Our Ref: 16015 – RFS Response – Huntlee Stage 2 - 20251024
Via: email

RE: DEVELOPMENT APPLICATION S100B – HUNTLEE NEW TOWN SUBDIVISION – SSD-70748466

MJD Environmental have undertaken a review of the approval issued by the NSW RFS (Ref: DA20250726002963-Response to Submissions-1).

Attachment 1 – APZ and BAL over detailed subdivision layout with Lot numbers

HUNTLEE STAGE 2 DA VILLAGE 2
CENTRAL & SOUTH DETAILED
SUBDIVISION BAL PLAN (3)

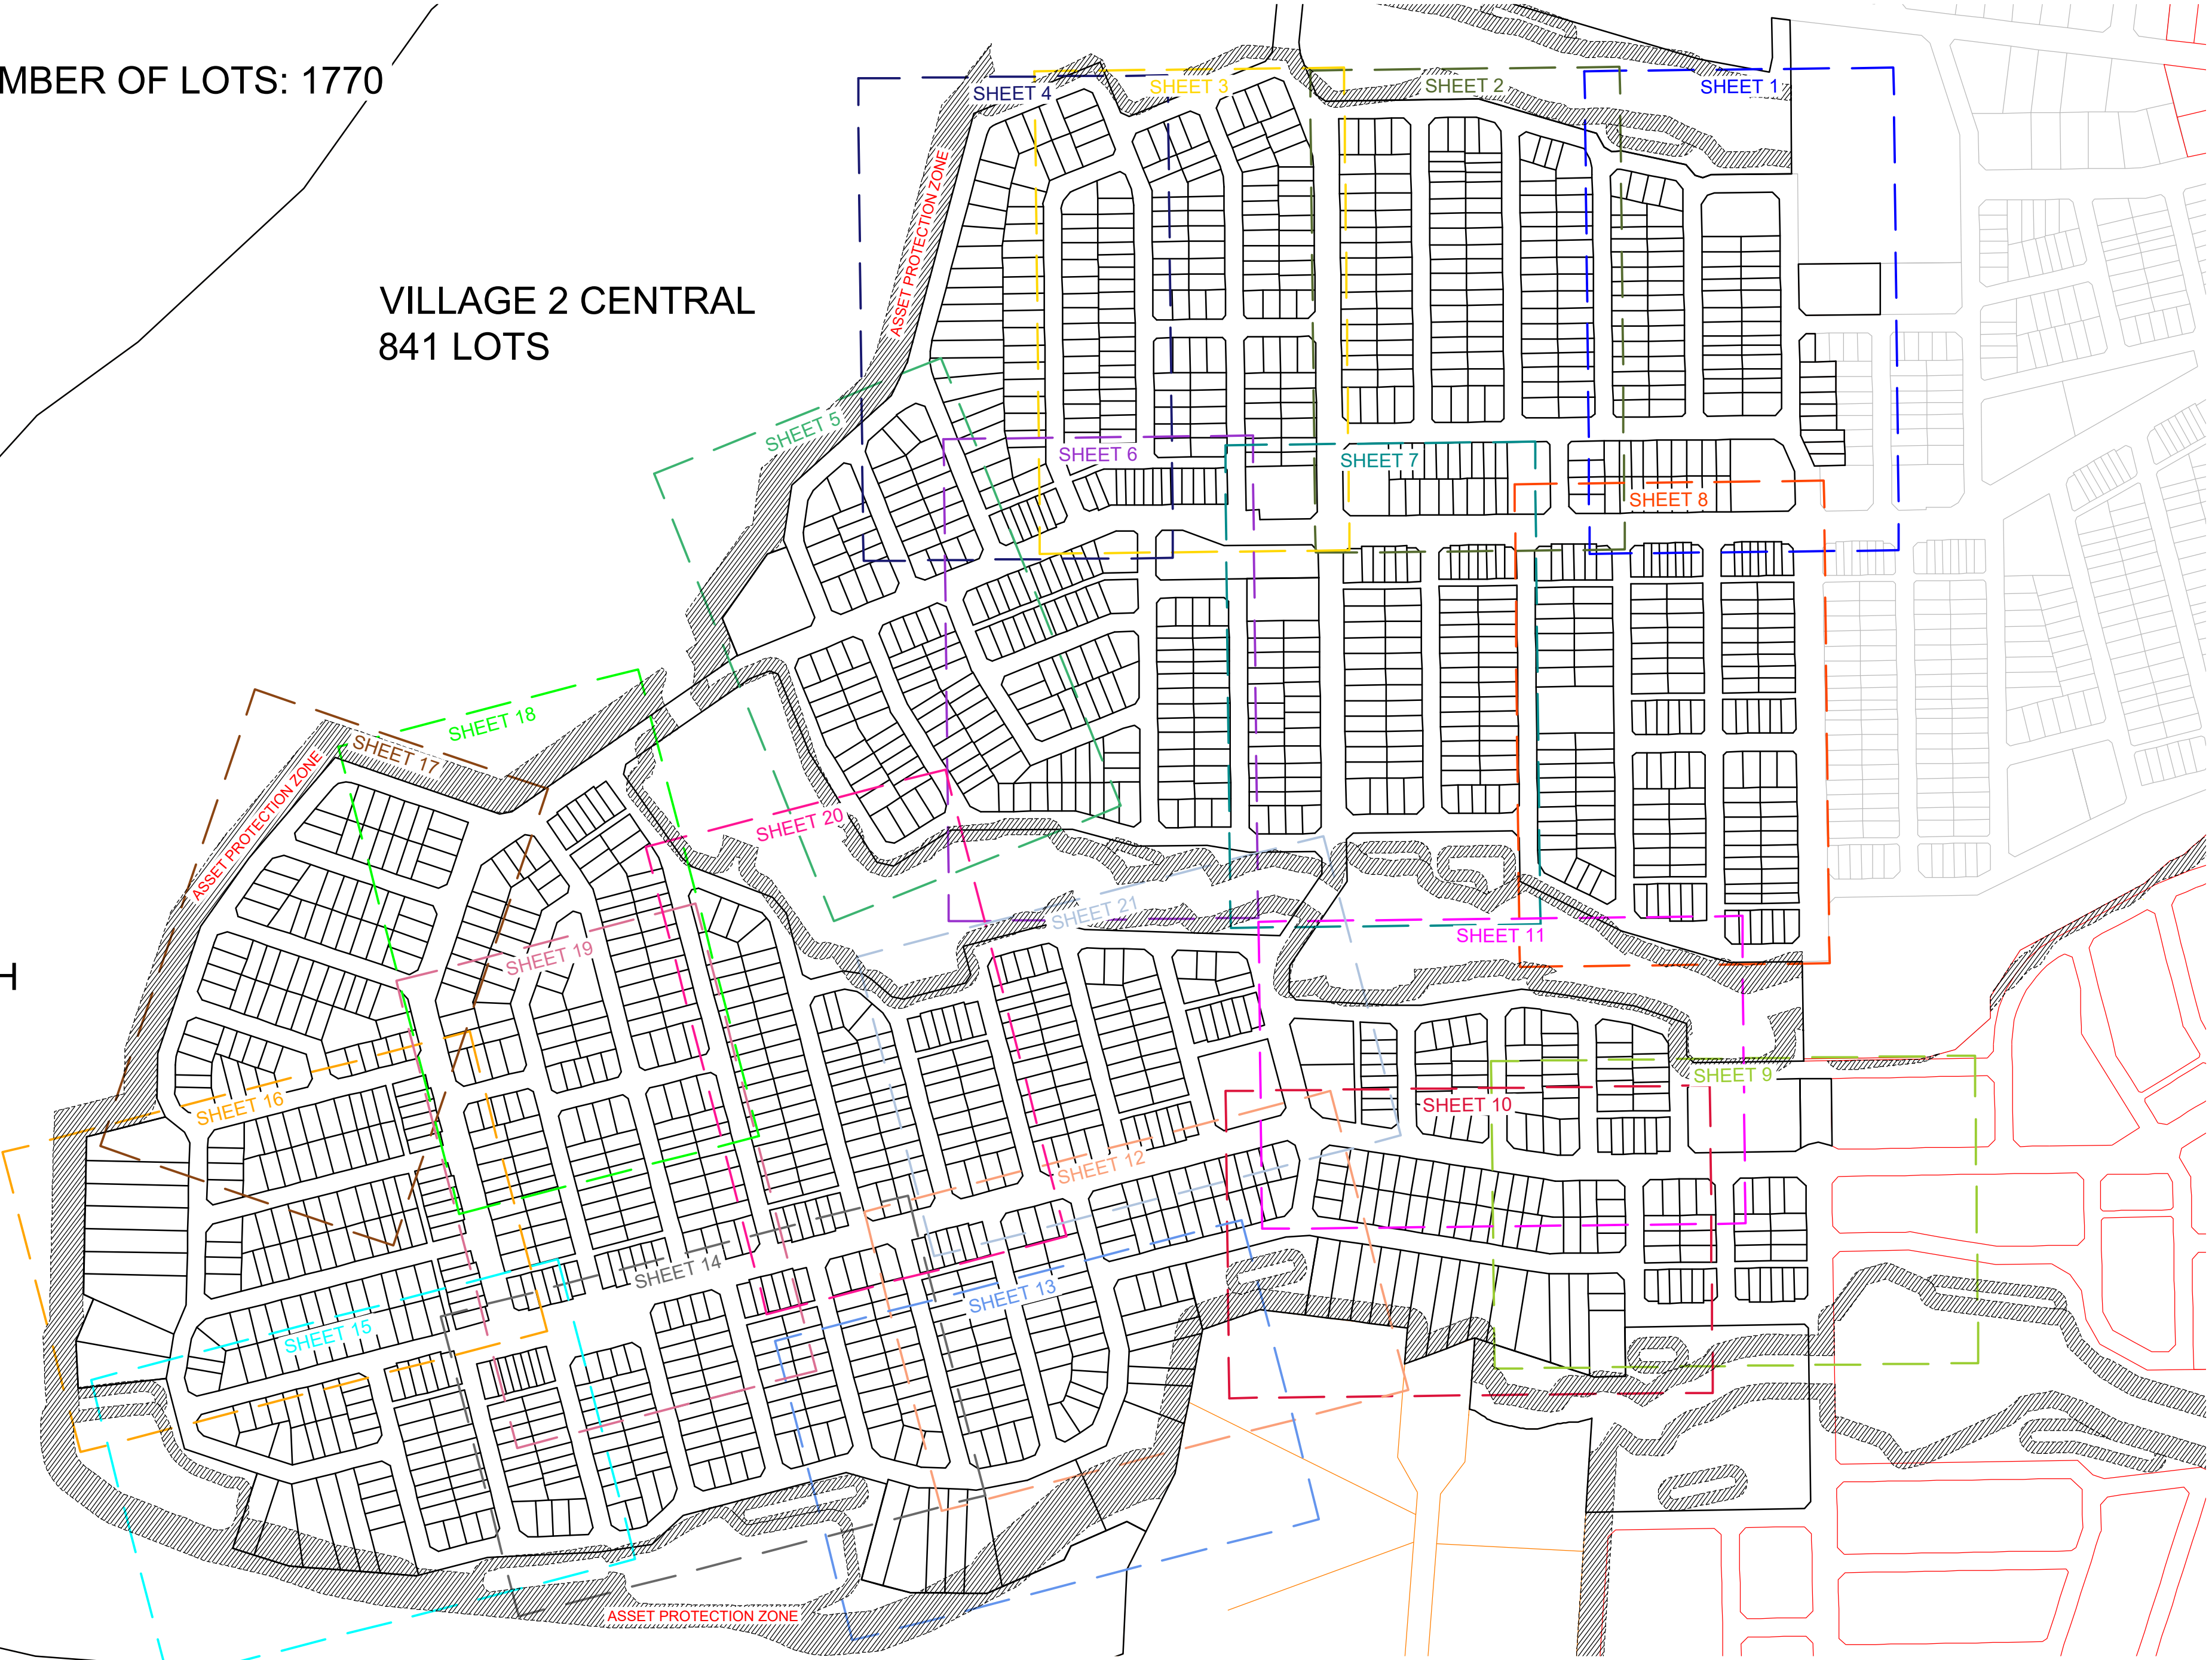
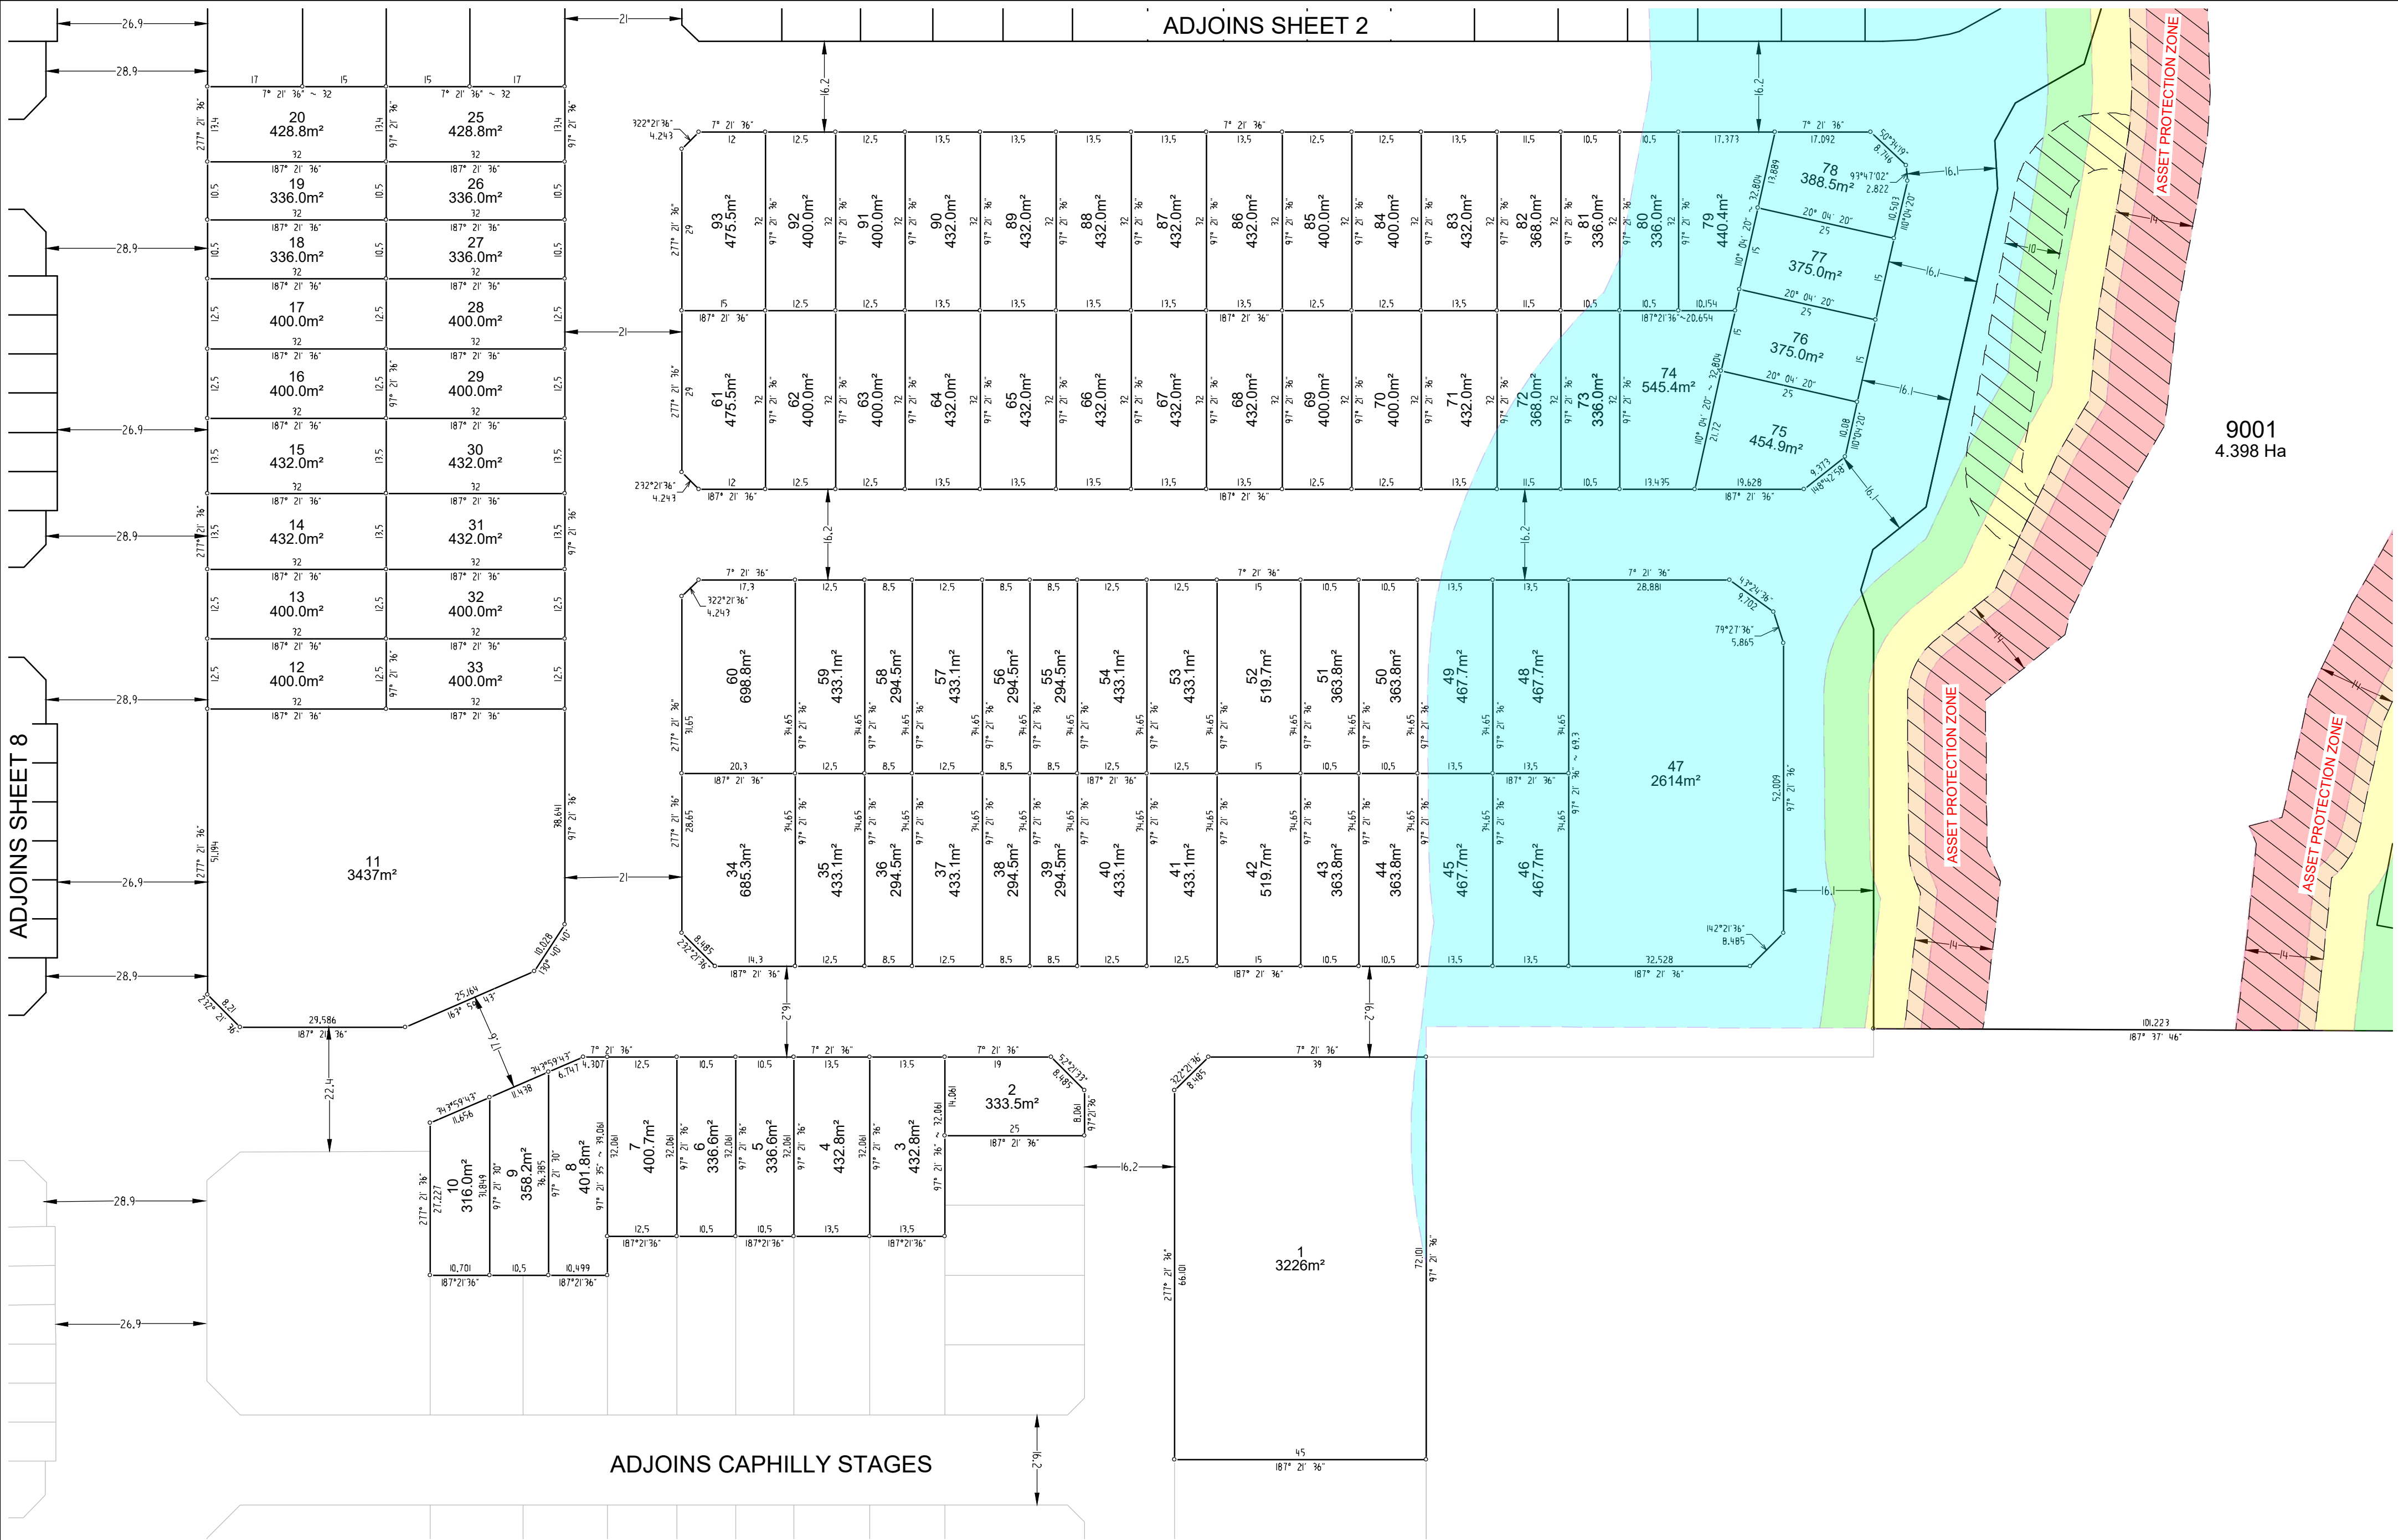
In response to the RFS commentary and request provided under approval Condition 3 and acknowledging aforementioned commentary contained under Condition 1 and Condition 2, please refer to **Attachment 1** that contains APZ and BAL per Figures 20 to 25 over the detailed subdivision layout with Lot numbers. A schedule of Lot numbers and applicable BAL ratings has been provided in **Attachment 2**, covering only those lots affected by BAL.

We request upon review the RFS approve and endorse the BAL plan to provide certainty of applicable BAL for each Lot.
